Packet Guide
City of Charlottesville
Board of Architectural Review
Regular Meeting
April 15, 2025 5:30 p.m.
Hybrid Meeting (In-person at Council Chamber and virtual via Zoom)

Recommendation for Special Exception Permits

Permit # PL-26-0126

Certificate of Appropriateness Application

Section 2.4.4 CX-8 Corridor Mixed Use 8: B.Building

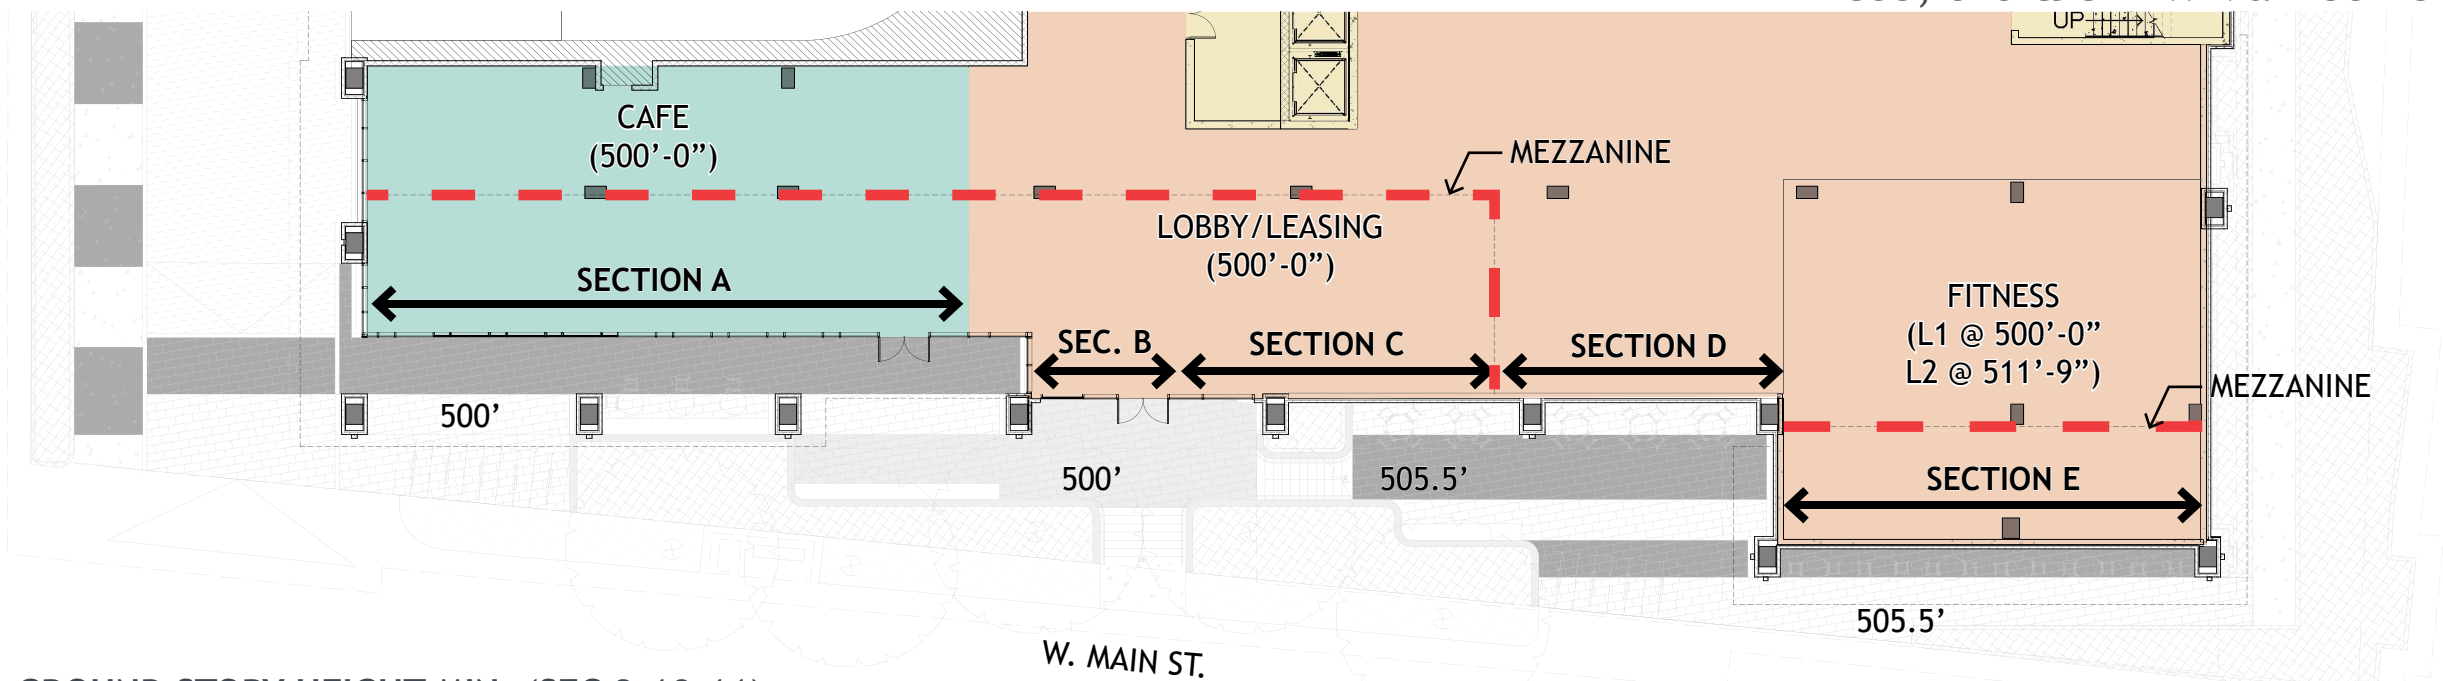
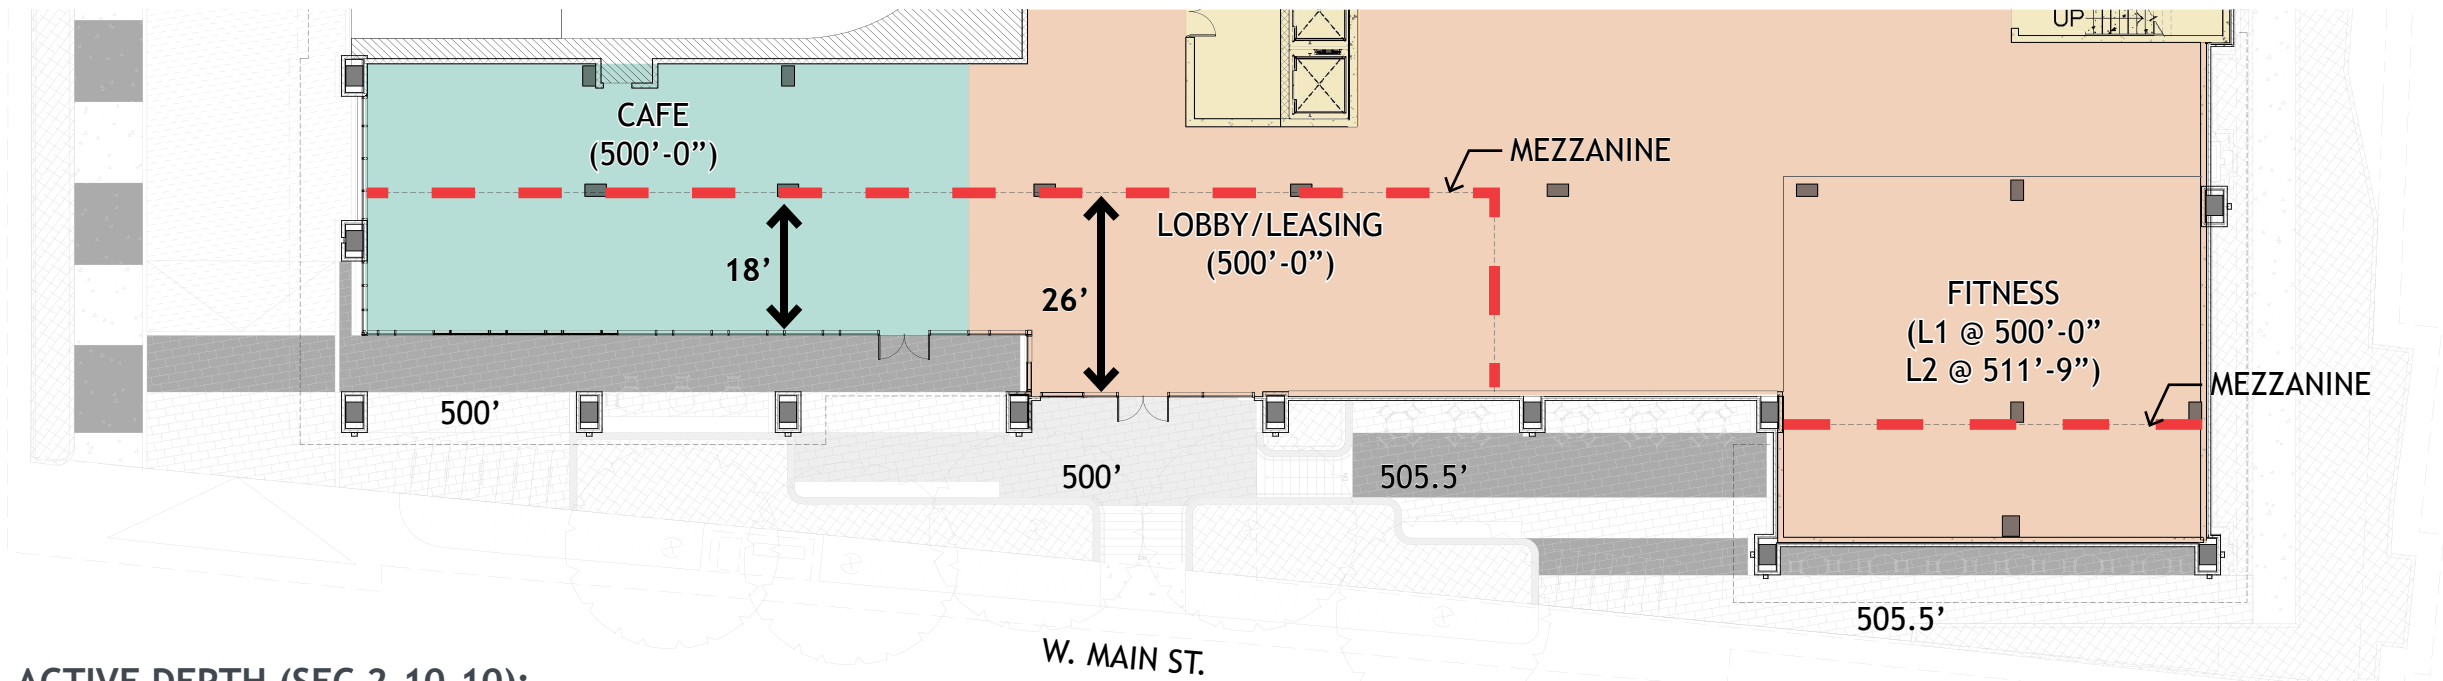
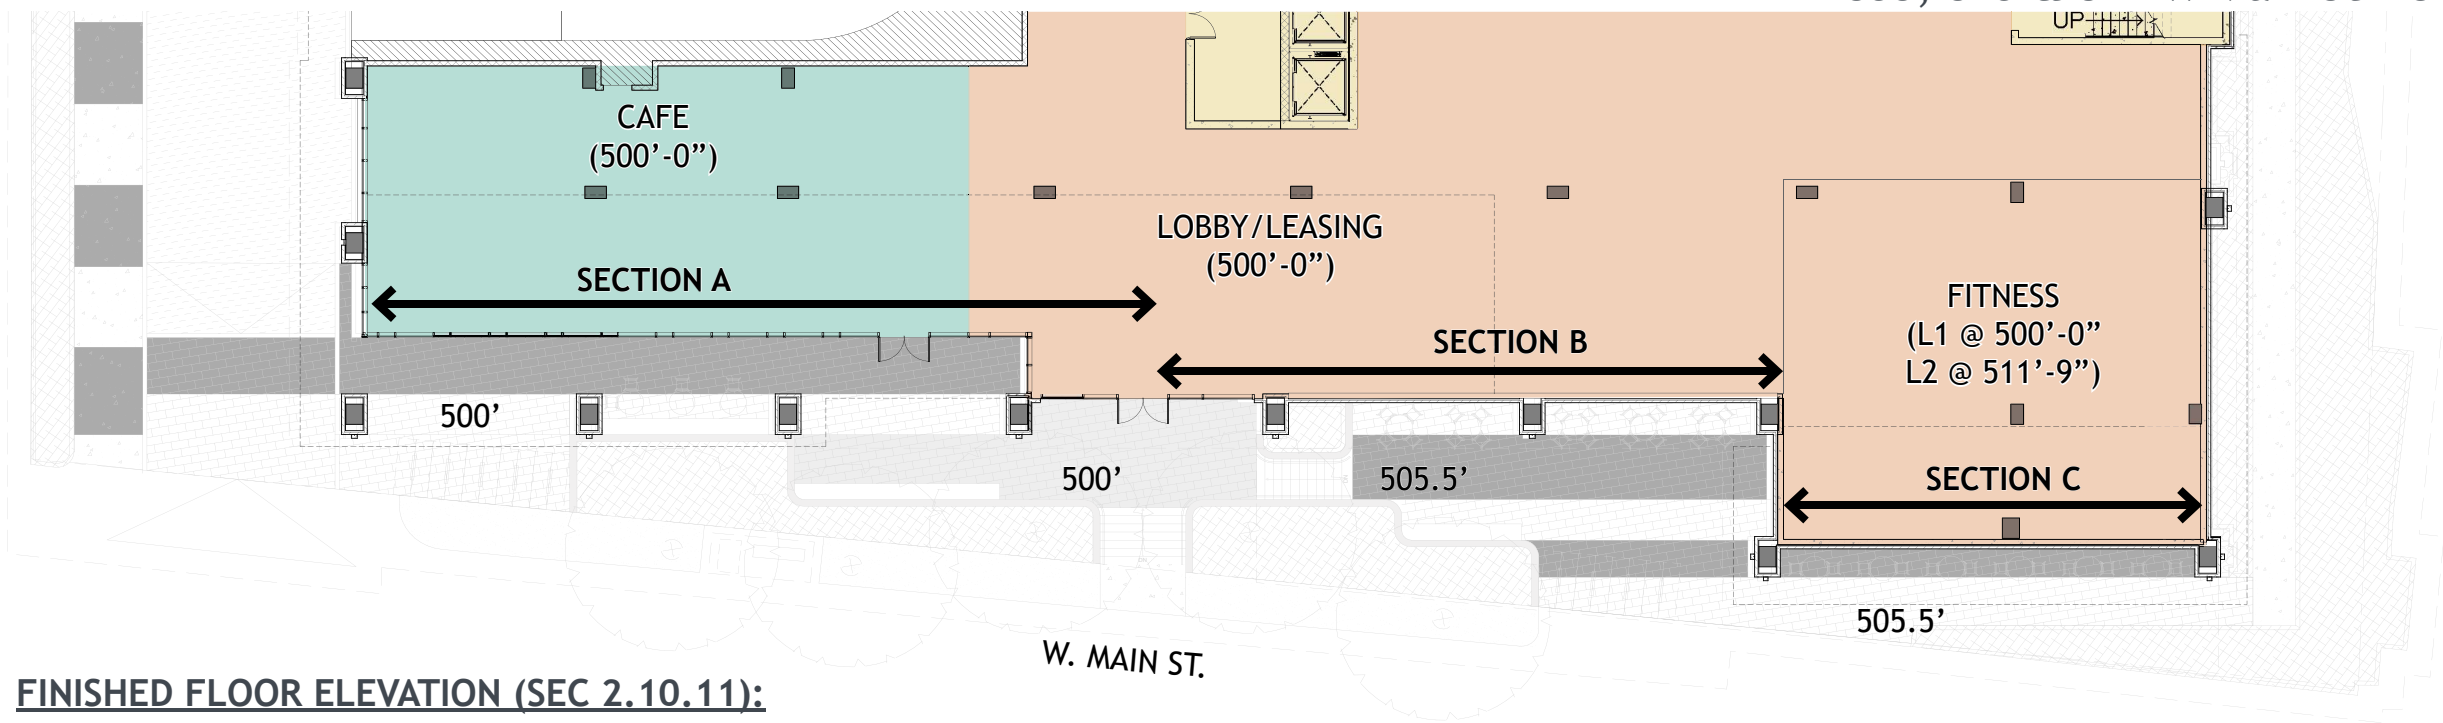
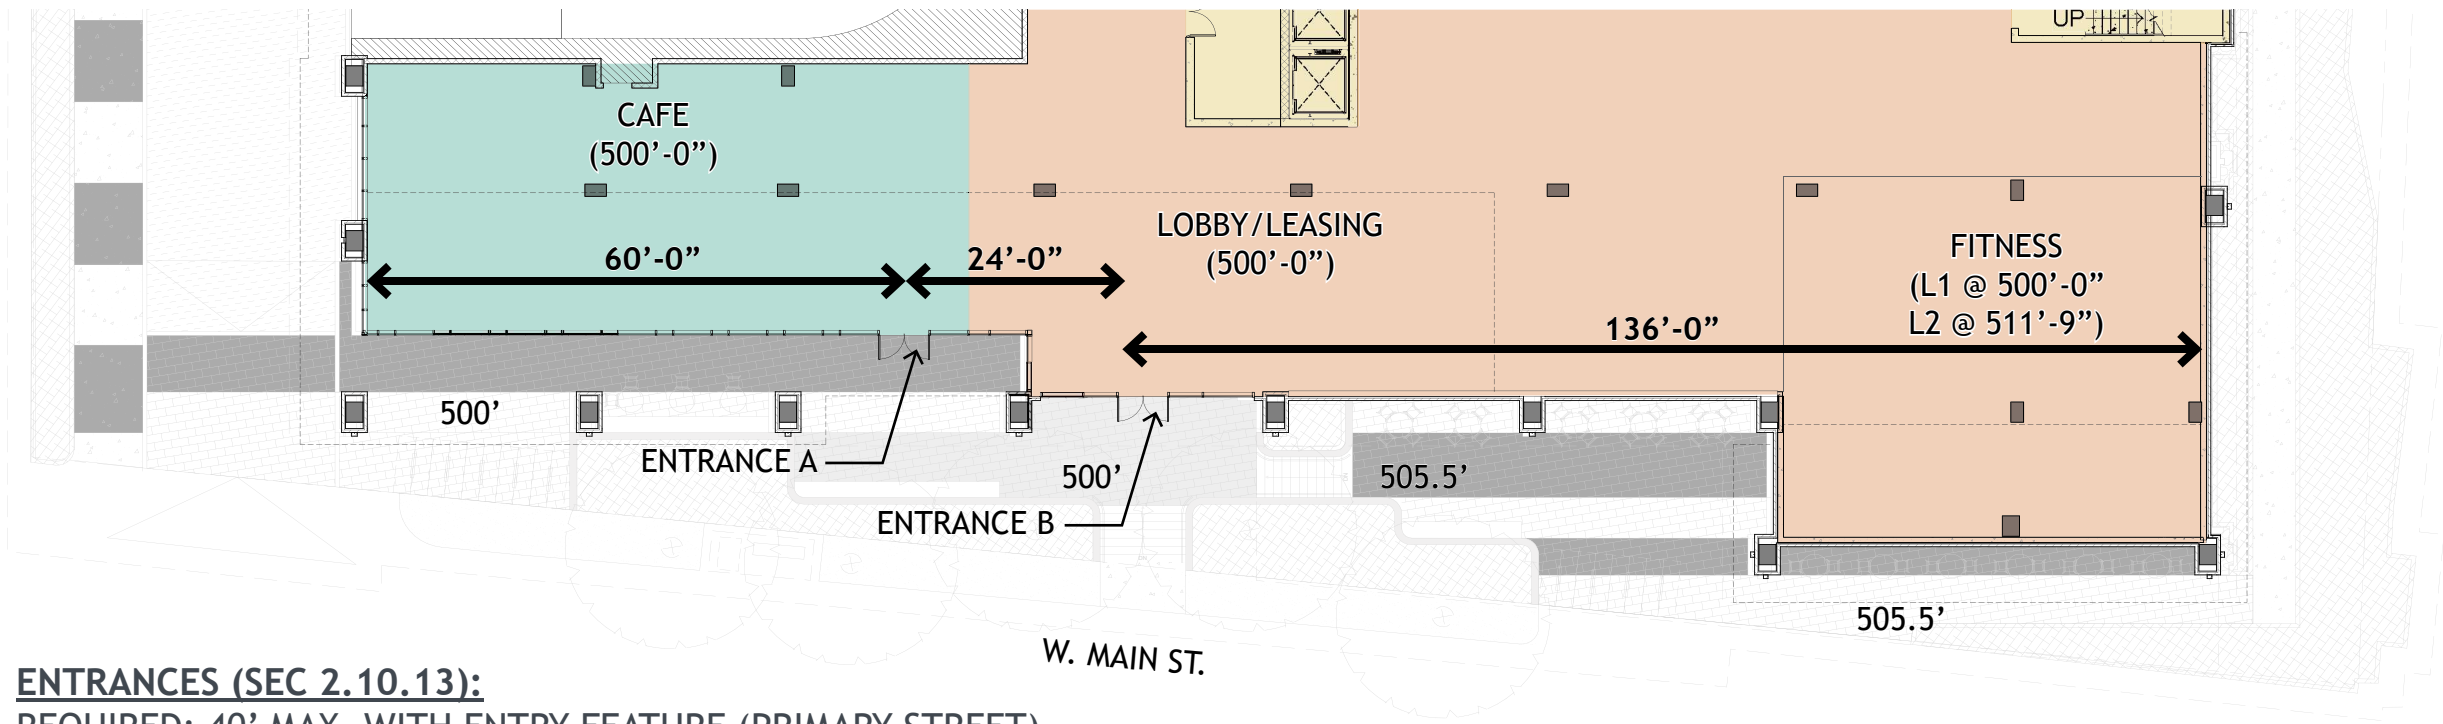
Per Section 2.4.2.B.3.F for non-residential spaces, the minimum ground floor height from finish grade is 14'. Due to existing grading conditions on the site, and to provide an accessible entry at level 1, the team requests an exception to the minimum ground floor height requirements for Section D as shown in Appendix A.1.

As indicated in Appendix A.1, the floor-to-floor height is 6'-3" from grade to level 2 at Section D due to the grade stepping up from 500' to 505.5' at the plan southeast corner. Section A, B, C and E meet the minimum ground floor height requirements as shown in Appendix A.1. Level 2 is proposed to extend Section D only to provide access to the amenity space on this level.

Per Section 2.4.2.B.5, street facing entry spacing shall be 40' maximum on primary streets. The team is requesting an exception to the entry spacing, as indicated in Appendix A.2, due to the existing grading conditions and the need to provide accessible entrances into the building from the public plaza.

GROUND STORY HEIGHT MIN. (SEC 2.10.11):
 REQUIRED: 14" MINIMUM (NON-RESIDENTIAL)
 PROVIDED: SECTION A & B : 23'-5" FLOOR TO FLOOR
 SECTION C : 17'-11" FLOOR TO FLOOR
 SECTION D : 6'-3" FLOOR TO FLOOR
 SECTION E : 17'-11" FLOOR TO FLOOR

ACTIVE DEPTH (SEC 2.10.10):
 REQUIRED: 15' (PRIMARY STREET)
 PROVIDED: 18'-26', WITH THE EXCEPTION OF THE SEGMENT BETWEEN LOBBY, LEASING AND FITNESS.

FINISHED FLOOR ELEVATION (SEC 2.10.11):
REQUIRED: -2' / 6" (NON-RESIDENTIAL)
PROVIDED: SECTION A : 0' (FROM PLAZA)
SECTION B : -5'-6" (FROM PLAZA)
SECTION C : -5'-6" (FROM PLAZA)

ENTRANCES (SEC 2.10.13):
REQUIRED: 40' MAX. WITH ENTRY FEATURE (PRIMARY STREET)
PROVIDED: SEE DIAGRAM
